File 1977-0046

Project Name: Replat of part of Cyphers Subdivision

Re: CITY FILE #46-77, CYPHERS SUBDIVISION REPLAT

Re: Oak Court in Cypher's Subdivision

Cyphers Subd.
9/9/77
J. Luke
Job # 771228

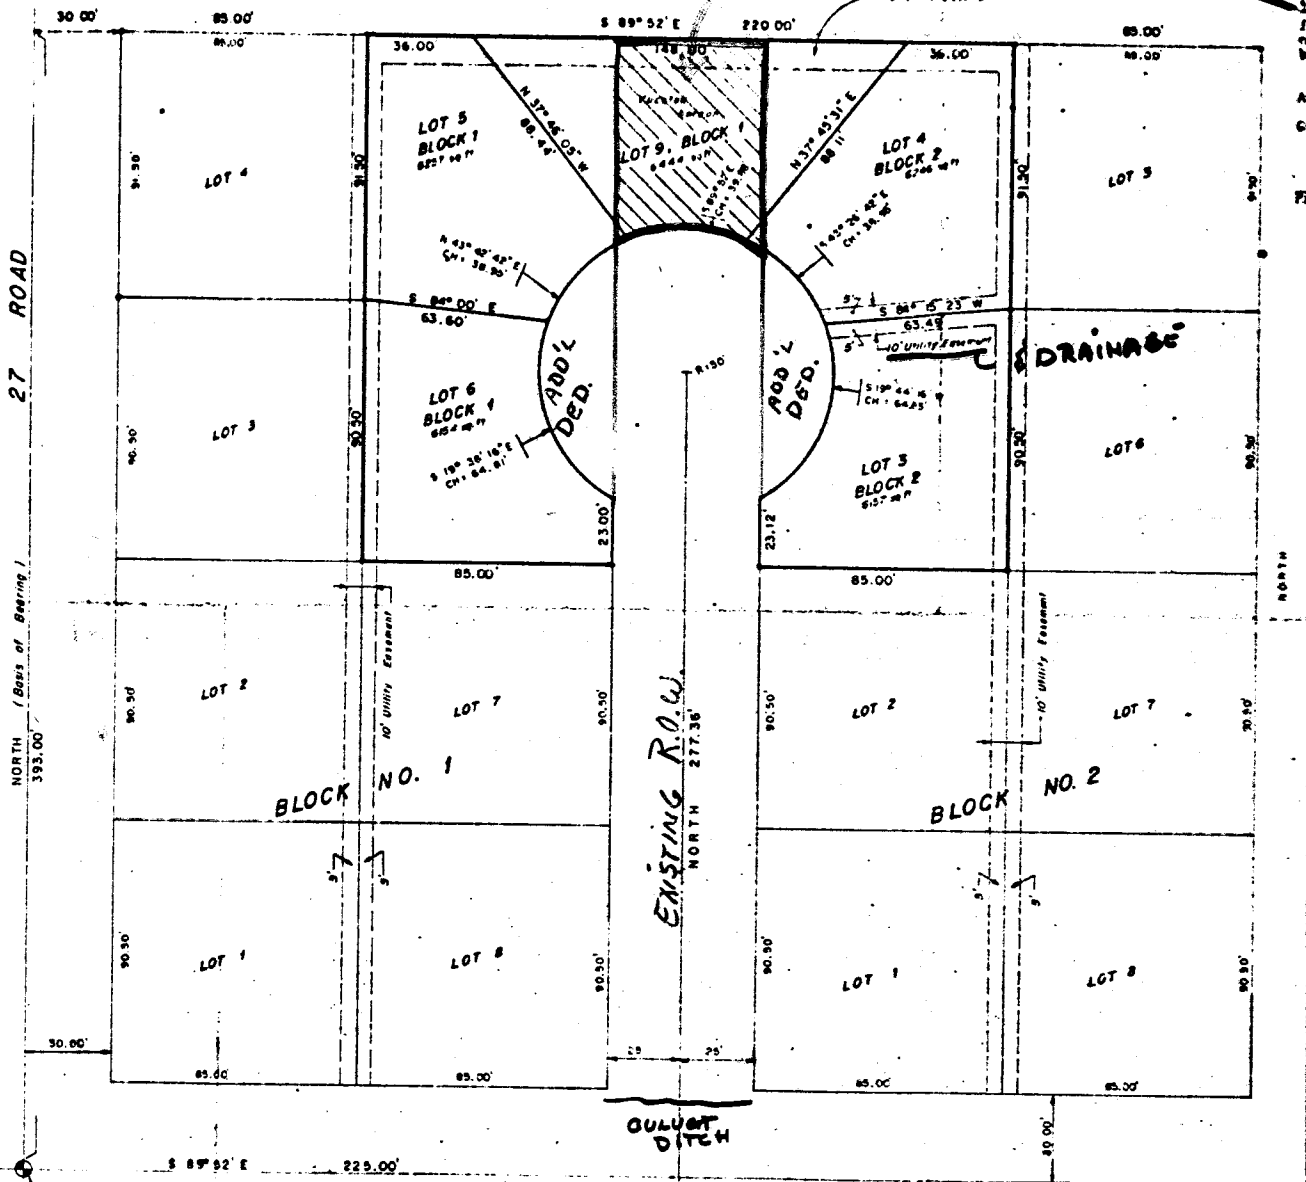
P.S. - overhead line crossing
 VACATED ST. IS COVERED BY
 10' easement shown. O.K.
 City Eng. - Imps. req'd
 To city stds. Easmt
 between lots 3 & 4 To
 be for util. & drainage.
 Culvert req'd at B³/₄ rd.
 20' radius to be ded. at
 B³/₄.

- 1) Subject to review comments
- 2) Ask developer to dedicate 20' radius at Oak cr. & B³/₄.

- a) Easement between lots three and four to read "utility and drainage easement"
- b) All street improvements to city standards including culvert required at B 3/4 and Oak Court.

The Planning Commission has also asked if you would consider dedicating a 20' radius on the Southeast corner of lot eight, block one and the Southwest corner of lot one, block two. This would provide a standard right-of-way radius on the turn from B 3/4 to Oak Court. This cannot be required as a condition of approval for the plat since it is not within that area being replated. If you have no objections to this, we would be glad to prepare the necessary paper work for your signature.
